Project	IEEE 802.16 Broadband Wireless Access Working Group <a href="http://ieee802.org/16">http://ieee802.org/16</a> >	
Title	Clarification of relation between Classifier Rule and PHS Rule	
Date Submitted	2005-07-08	
Source(s)	Pieter-Paul Giesberts,	Voice: +31-30-6001619
	Leon Zegers	Fax: +31-30-6001660 mailto: giesberts@motorola.com
	Motorola Marconibaan 57 3439 MR Nieuwegein Netherlands	
Re:	Call for Comments, Sponsor Ballot on IEEE P802.16-2004/Cor1/D3	
Abstract	Clarification of relation between Classifier Rule and PHS Rule	
Purpose	Adopt proposed changes	
Notice	This document has been prepared to assist IEEE 802.16. It is offered as a basis for discussion and is not binding on the contributing individual(s) or organization(s). The material in this document is subject to change in form and content after further study. The contributor(s) reserve(s) the right to add, amend or withdraw material contained herein.

## Clarification of relation between Classifier Rule and PHS Rule

Figure 95 – Theory of Operation Object Model

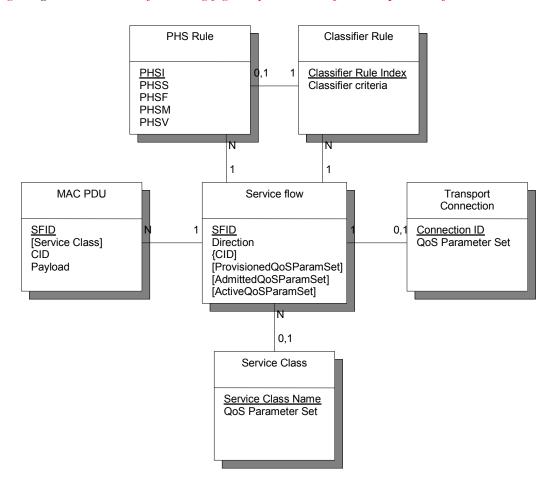
[Change page 59, line 63 as follows and replace Figure 95]

<u>ReplaceChange</u> Figure 95 with the following figure by addition of "Transport" before "Connection":
